Access Compliance Report

Public Rights-of-Way

Intersection ID: 48984	Main Street: ASHTON_GATE_DR	Cross Street: KINGSDOWN_AV	Location: SE
ADA ID: B222252D45E4	Ramp Type: BlendTrans1	Initial Pass/Fail: Fail	Overall Compliance: No
Severity Score: 12.5			
Codes/Mitigation Info/Possible Solution		Field Measurements/Component Compliance

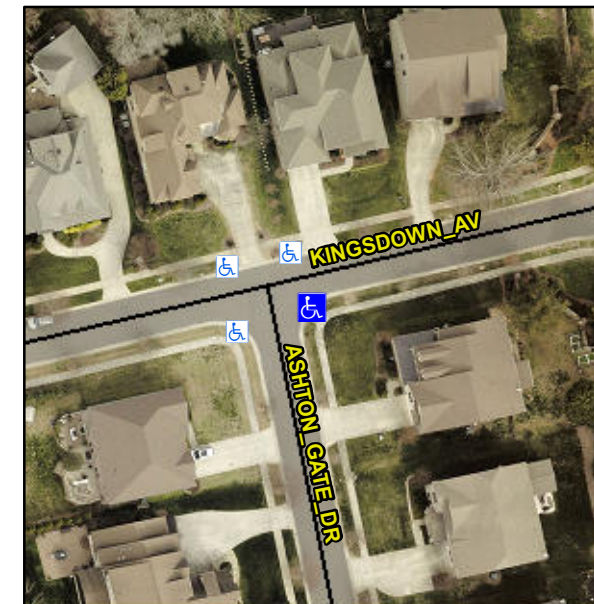
Not Found, R304.5.3

Compliance	Description	Data	Compliance	Description	Data
N/A	Ramp Length (in)	70.0	Yes	BlendTrans Slope (%)	2.8
Yes	Ramp Width (in)	49.5	No	BlendTrans XSlope (%)	5.4
N/A	Flare Type LT	N/A	N/A	Flare Type RT	N/A
N/A	Flare Slope LT (%)	N/A	N/A	Flare Slope RT (%)	N/A
N/A	Flare Traversable LT?	N/A	N/A	Flare Traversable RT?	N/A
N/A	Landing Length (in)	N/A	N/A	DWS Provided?	N/A
N/A	Landing Width (in)	N/A	N/A	DWS Contrast?	N/A
N/A	Landing Slope (%)	N/A	N/A	DWS Length (in)	N/A
N/A	Landing X Slope (%)	N/A	N/A	DWS Full Width?	N/A
N/A	Landing Curb? (Y/N)	N/A	N/A	DWS Offset (in)	N/A
N/A	Shared Landing?	N/A			
N/A	Gutter Ponding?	N/A	N/A	Gutter Slope (%)	N/A
N/A	Gutter Lip Ht (in)	N/A	N/A	Gutter X Slope (%)	N/A
N/A	Painted X Walk1?	No	N/A	Painted X Walk2?	No
	X Walk 1 Direction	To NW		X Walk 2 Direction	To SW
	X Walk 1 Width (in)	N/A		X Walk 2 Width (in)	N/A
	X Walk 1 Slope (%)	2.5		X Walk 2 Slope (%)	0.2
	X Walk 1 X Slope (%)	0.8		X Walk 2 X Slope (%)	4.4

N/A	Ramp inside XWalk1?	N/A	N/A	Ramp inside XWalk2?	N/A
	Road Slope (%)	4.6		Clear Space?	N/A
	Road X Slope (%)	2.3	N/A	Clear Space to XWalk (in)	N/A
N/A	Any Obstructions?	N/A	N/A	Storm Grate/Utility Hazard?	N/A
	Obstruction Type			Storm Grate/Utility Type	
		N/A			N/A
			Yes	Surface Condition? (G/P)	Good
			No	Curb Slope (%)	7.4

Remove & Replace Curb Ramp With Two New Directional Ramps or Equivalent.
